Addendum Three

The Renovations & Restorations of the Westport Community Center

Issued: Monday, December 19, 2016

1 Typical Work Counter Detail

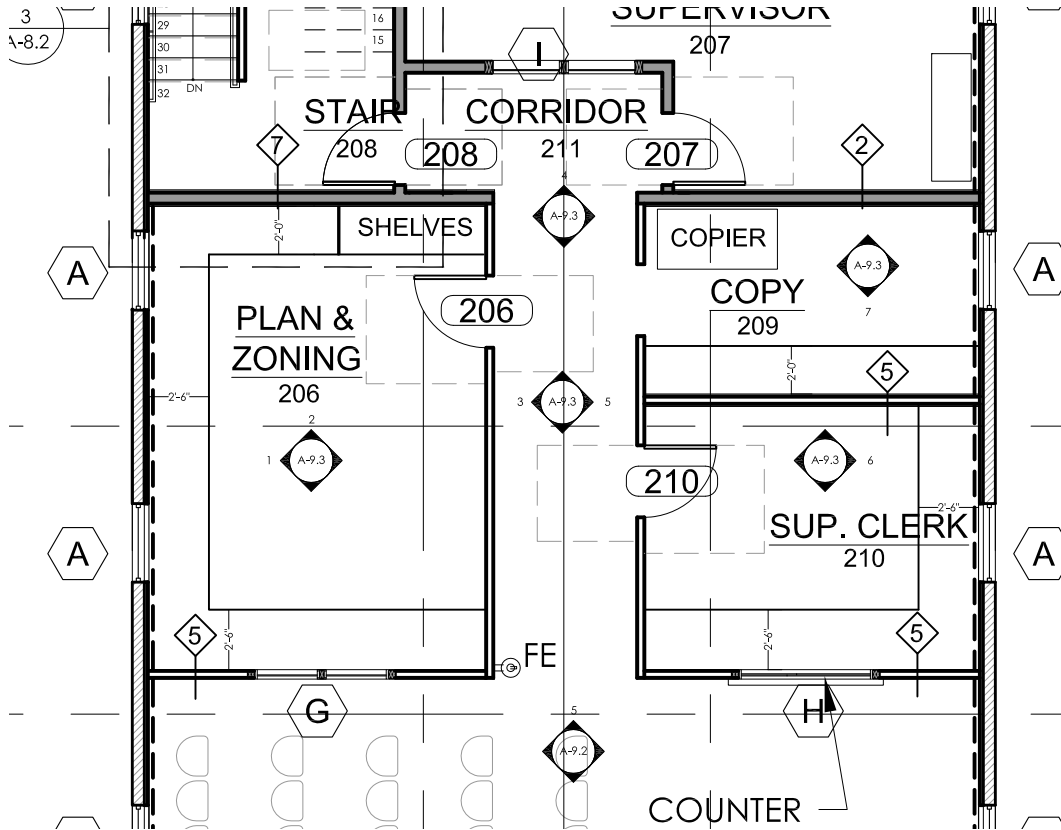
23. Are the countertops in 206, 209,210 plastic laminate? What is the extent of the tops and how deep are they?

Counters are Plastic Laminate with wood nosing – see attached detail and sketch.

SK 4 - Westport Community Center
December 19, 2016

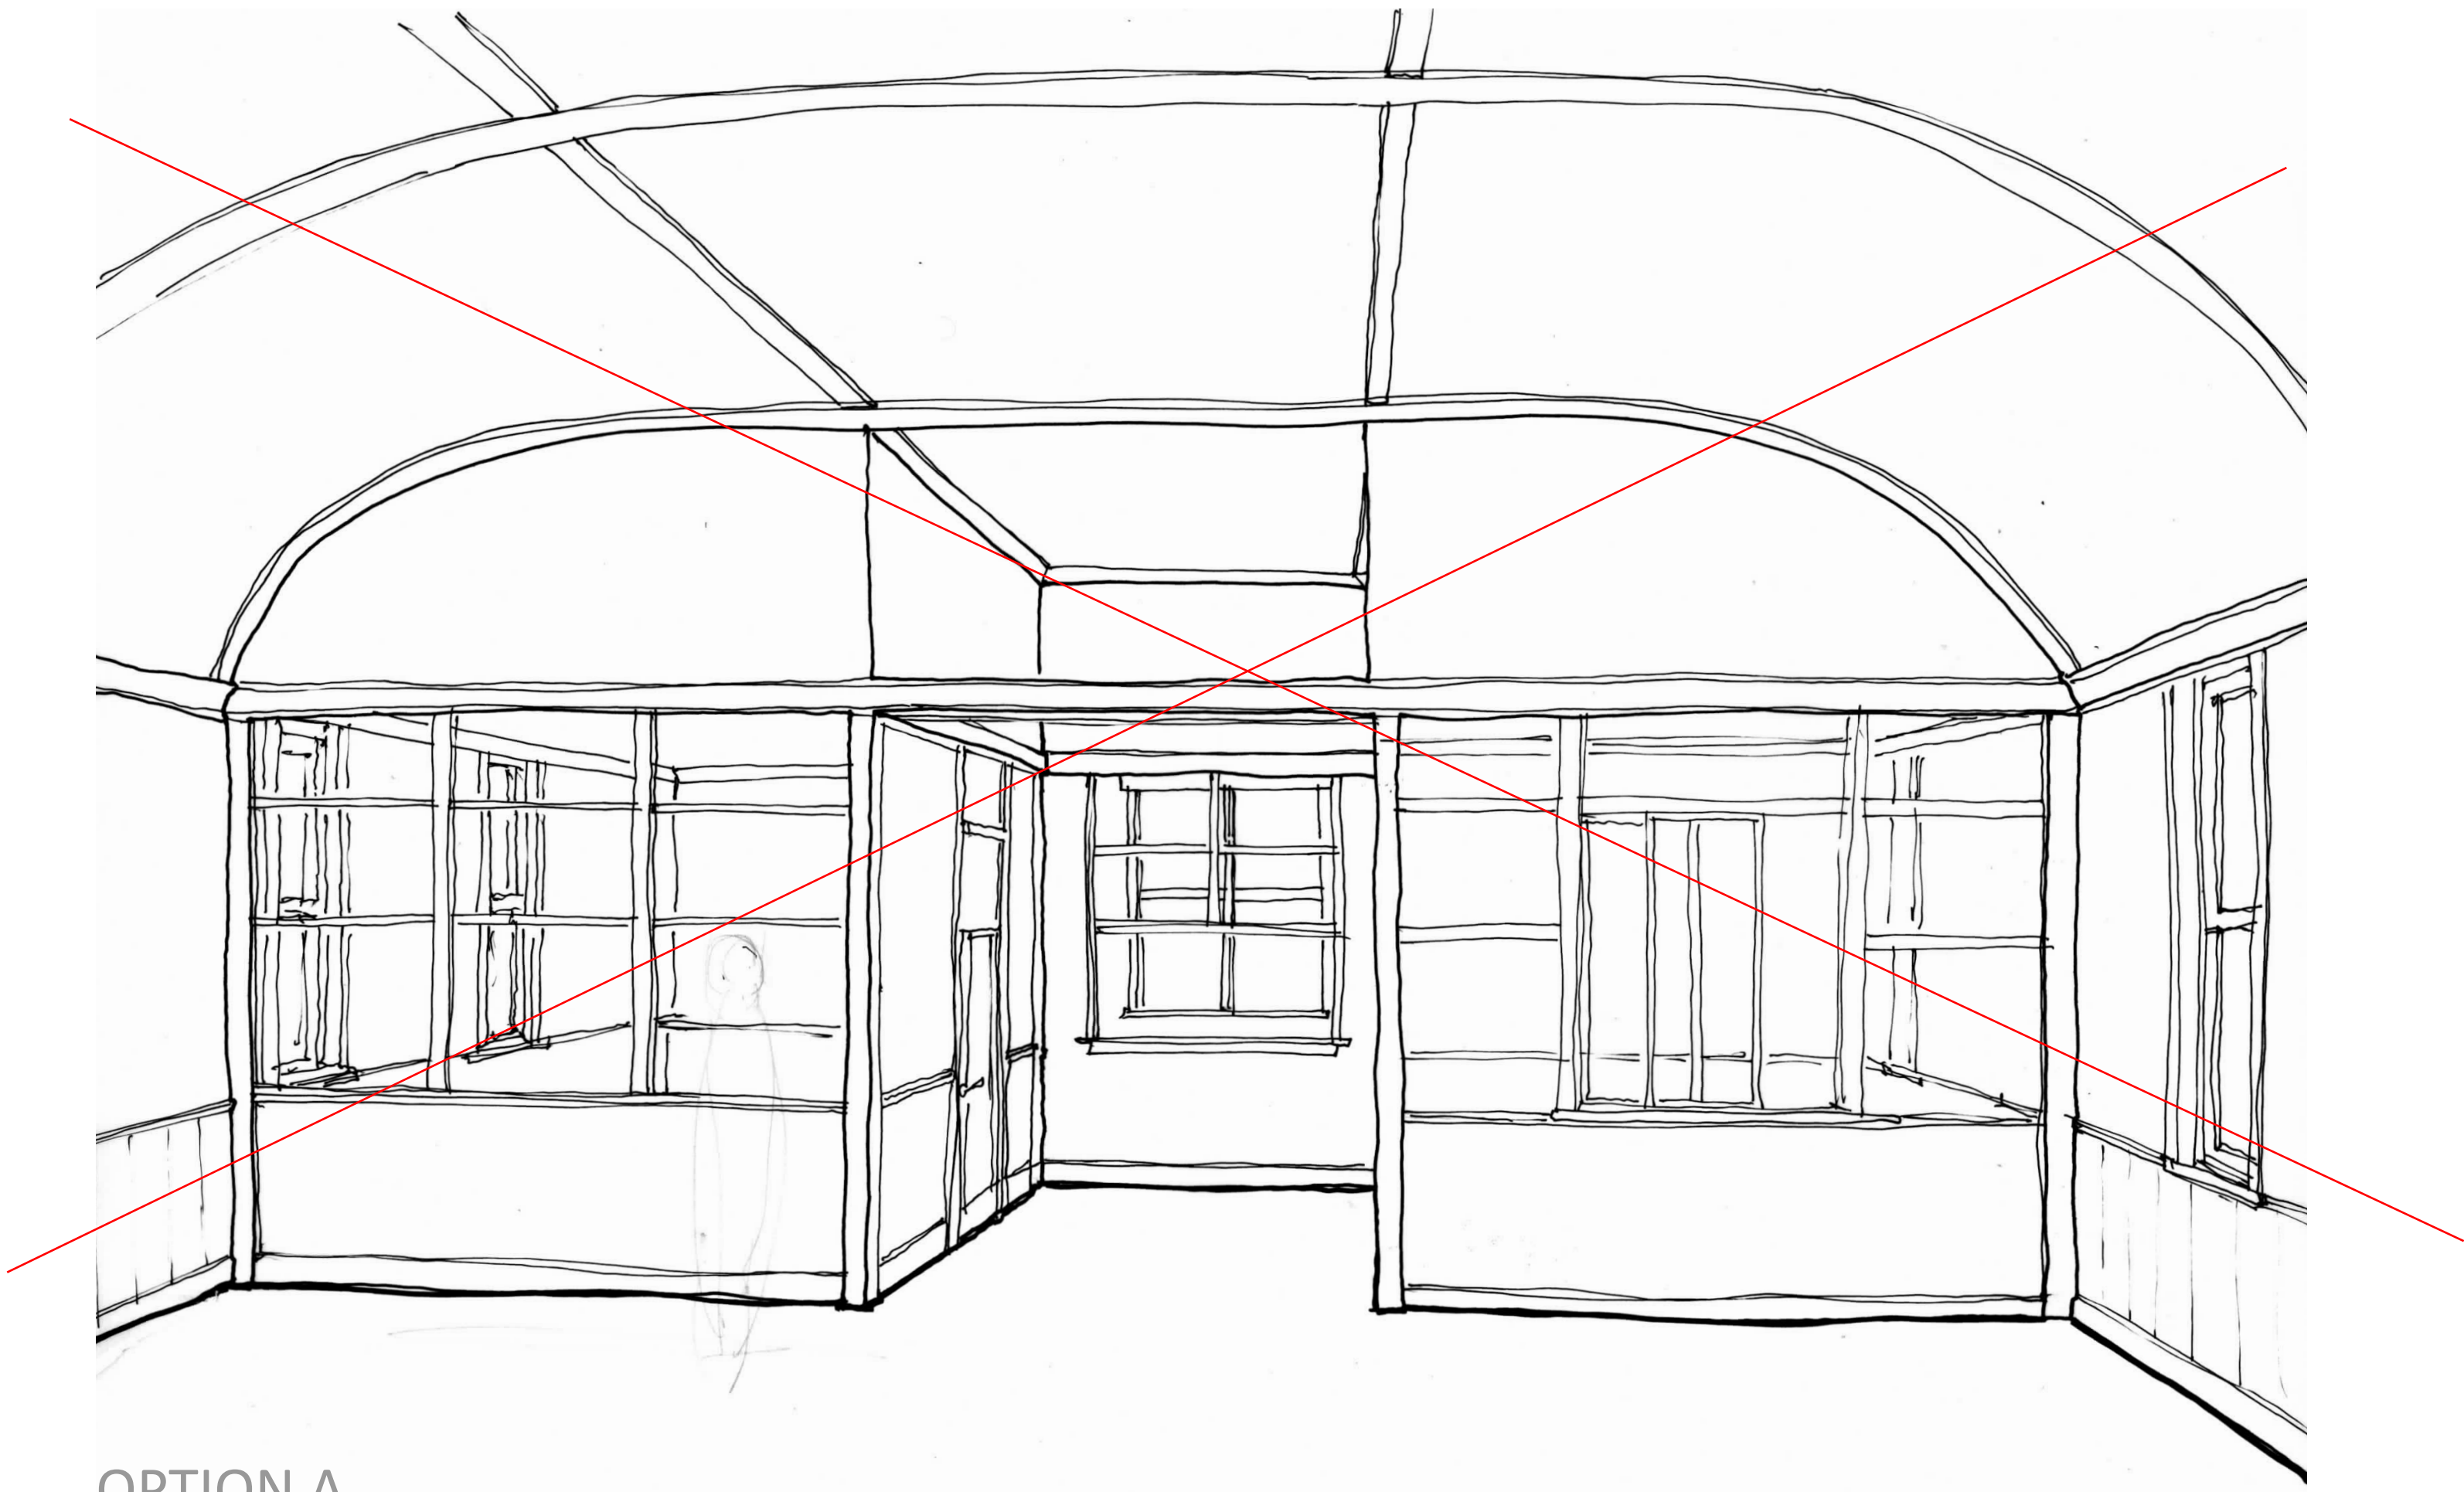
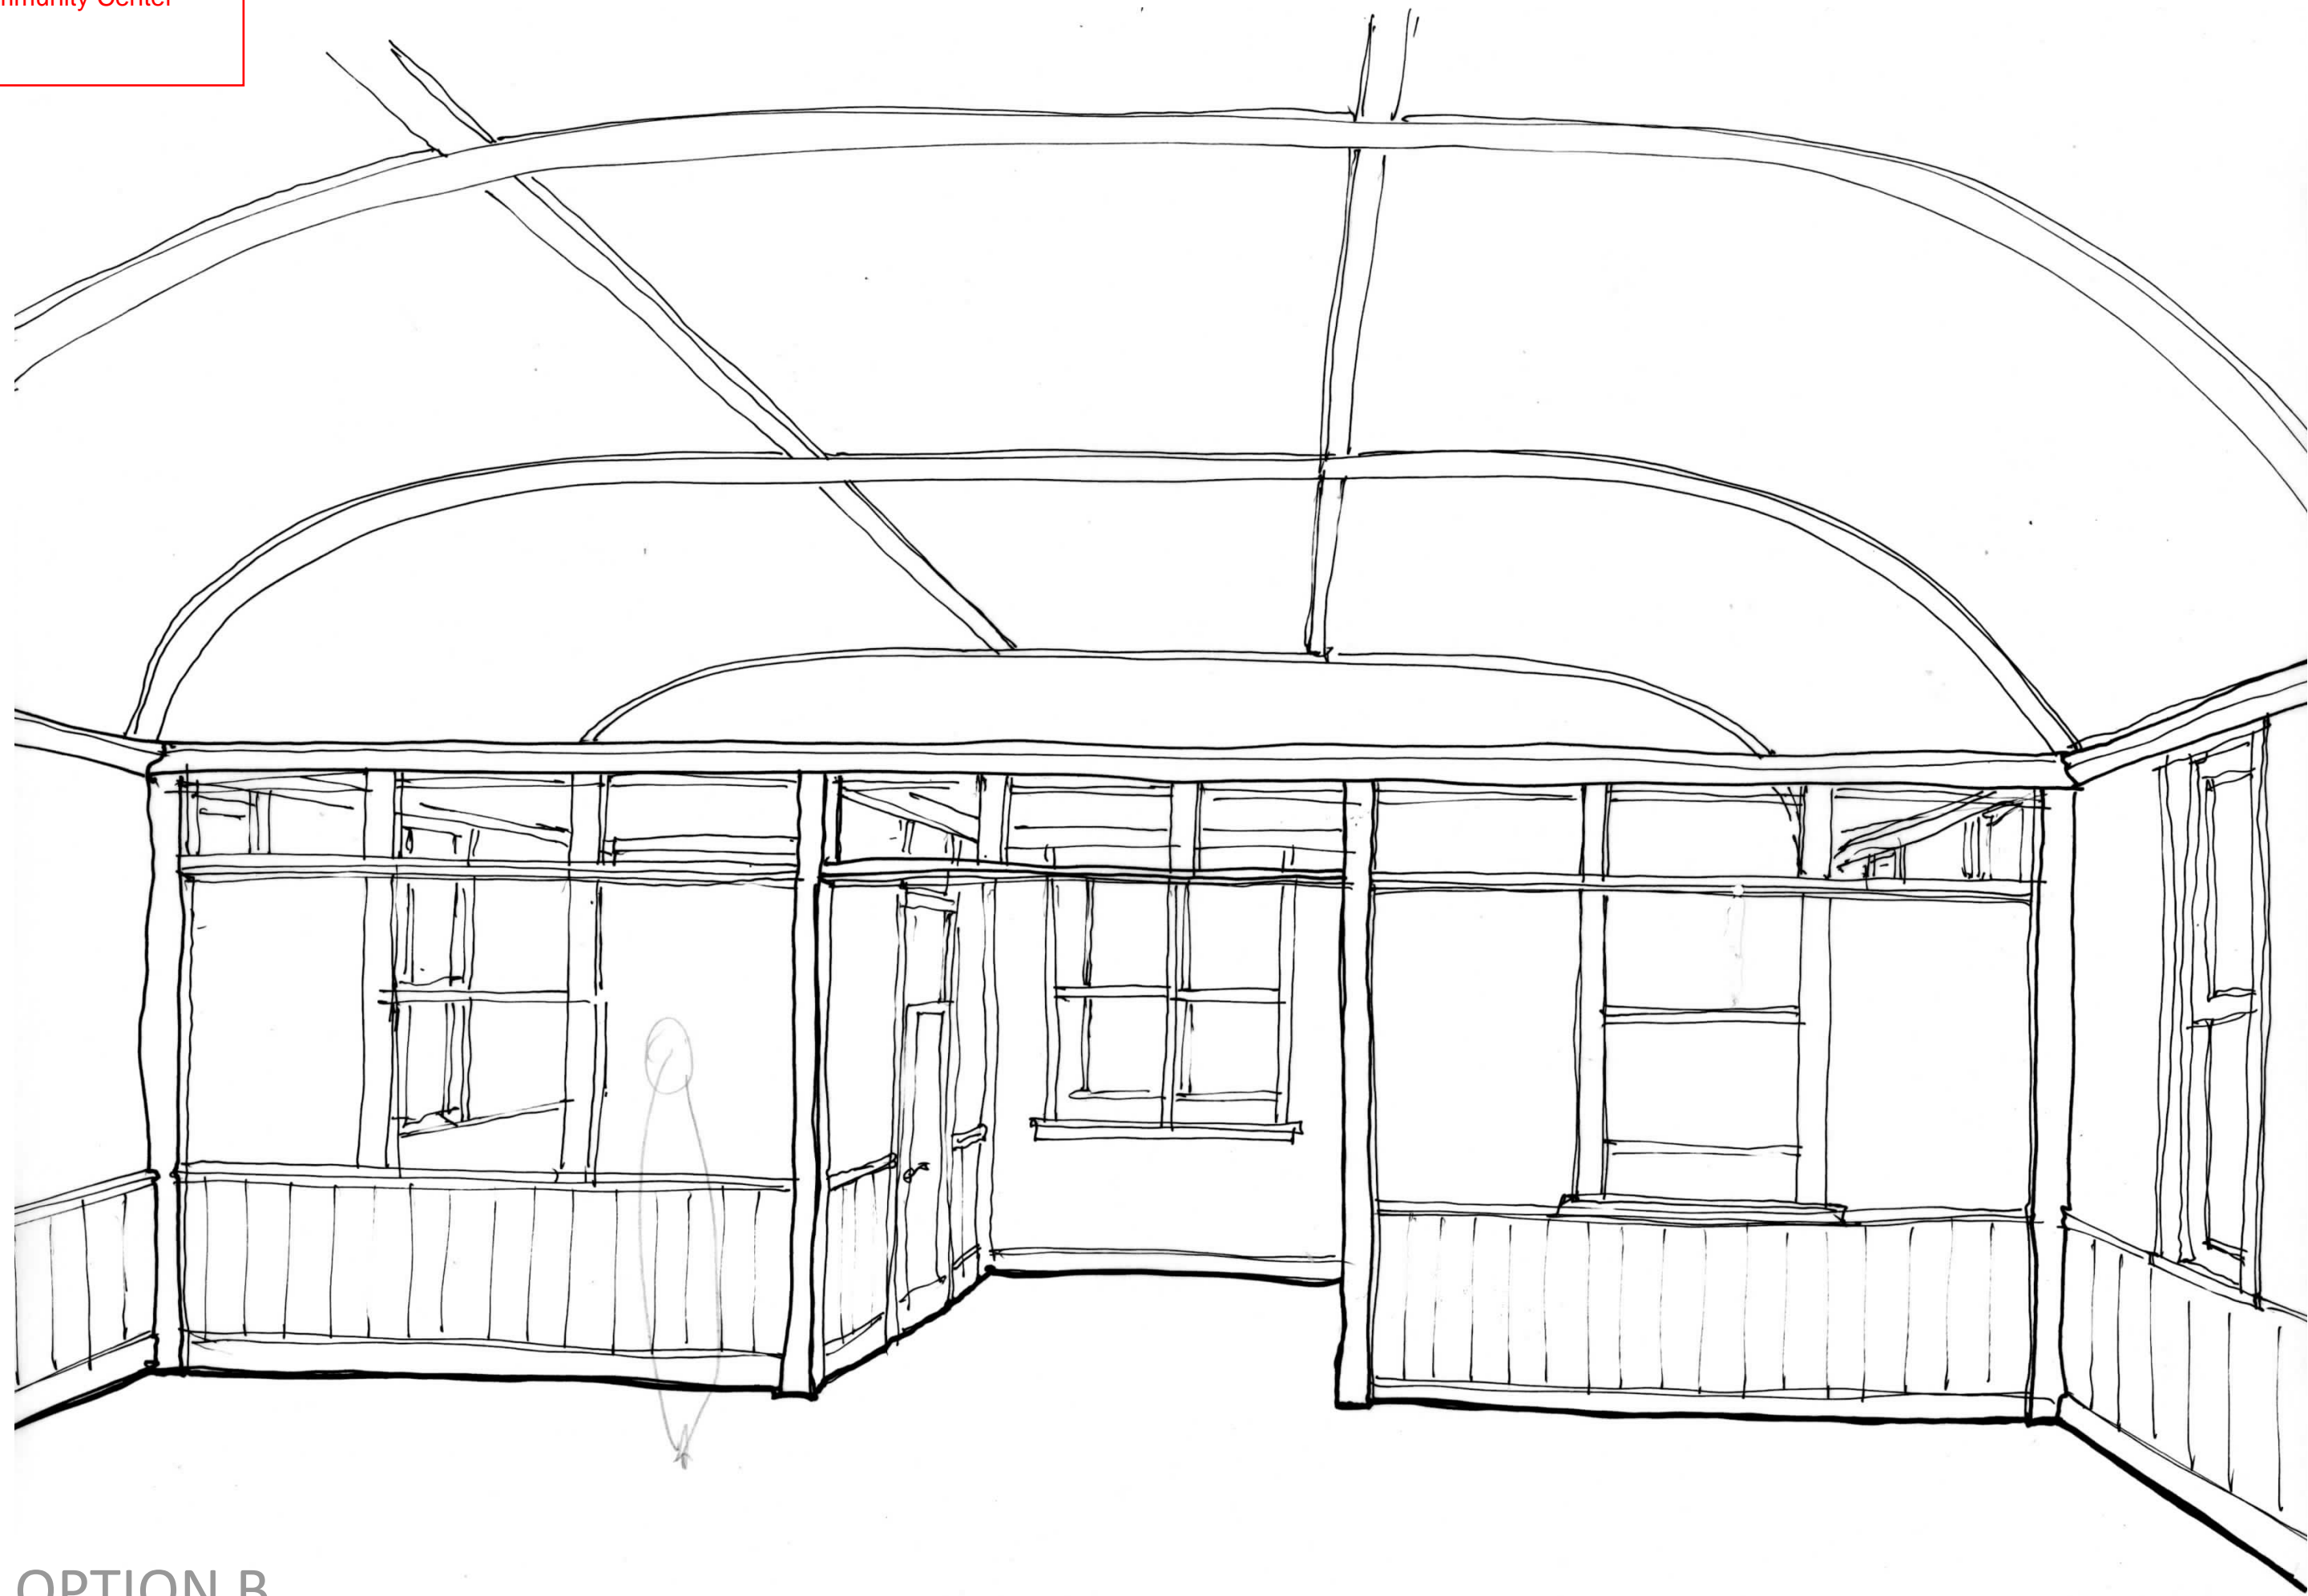
22. I am unable to find any drawing depicting woodwork on the vaulted ceiling on the main floor, it is scheduled and specified.

The only wood on the ceiling of the meeting room shall be the straps as shown on the attached sketches SK 4 & 5. Otherwise the ceiling is gypsum wallboard.
